Access Compliance Report

Public Rights-of-Way

(Curb Ramps)

Intersection ID: 52453	Main Street: PAT_GARRETT_ST	Cross Street: DOUBLE_OAKS_RD	Location: SE
ADA ID: 682C3BE3A4F4	Ramp Type: Perp	Initial Pass/Fail: Pass	Overall Compliance: No
Severity Score: 15			
Codes/Mitigation Info/Possible Solution		Field Measurements/Component Compliance

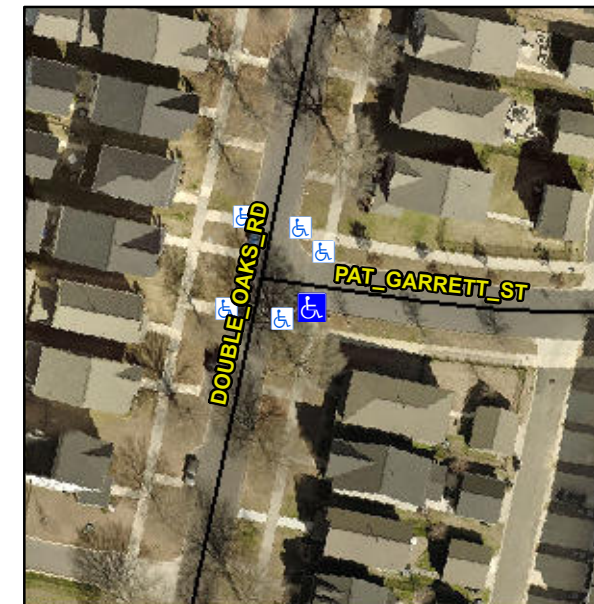
Not Found, R304.2.2-Perp, R304.3.2-Para, R302.7, R302.7.2

Compliance	Description	Data	Compliance	Description	Data
N/A	Ramp Length (in)	92.0	Yes	Ramp Slope (%)	7.3
Yes	Ramp Width (in)	70.0	Yes	Ramp XSlope (%)	1.1
Yes	Flare Type L	Curbed_NoWalkSurface	Yes	Flare Type RT	N/A
Yes	Flare Slope LT (%)	N/A	N/A	Flare Slope RT (%)	N/A
N/A	Flare Traversable LT?	No	N/A	Flare Traversable RT?	No
Yes	Landing Length (in)	71.0	Yes	DWS Provided?	Yes
Yes	Landing Width (in)	71.0	Yes	DWS Contrast?	Yes
No	Landing Slope (%)	4.4	Yes	DWS Length (in)	24.0
Yes	Landing X Slope (%)	0.6	Yes	DWS Full Width?	Yes
N/A	Landing Curb? (Y/N)	No	Yes	DWS Offset (in)	2.0
N/A	Shared Landing?	Yes			
No	Gutter Ponding?	Yes	Yes	Gutter Slope (%)	4.2
No	Gutter Lip Ht (in)	2.0	Yes	Gutter X Slope (%)	0.1
N/A	Painted X Walk1?	No	N/A	Painted X Walk2?	N/A
	X Walk 1 Direction	To N		X Walk 2 Direction	N/A
N/A	X Walk 1 Width (in)	N/A	N/A	X Walk 2 Width (in)	N/A
	X Walk 1 Slope (%)	3.5		X Walk 2 Slope (%)	N/A
	X Walk 1 X Slope (%)	1.1		X Walk 2 X Slope (%)	N/A

N/A	Ramp inside XWalk1?	N/A	N/A	Ramp inside XWalk2?	N/A
	Road Slope (%)	N/A	N/A	Clear Space?	Yes
	Road X Slope (%)	N/A	N/A	Clear Space to XWalk (in)	N/A
Yes	Any Obstructions?	No	Yes	Storm Grate/Utility Hazard?	No
	Obstruction Type			Storm Grate/Utility Type	
		N/A			N/A
			Yes	Surface Condition? (G/P)	Good

Possible Solutions:

Remove & Replace Entire Ramp.
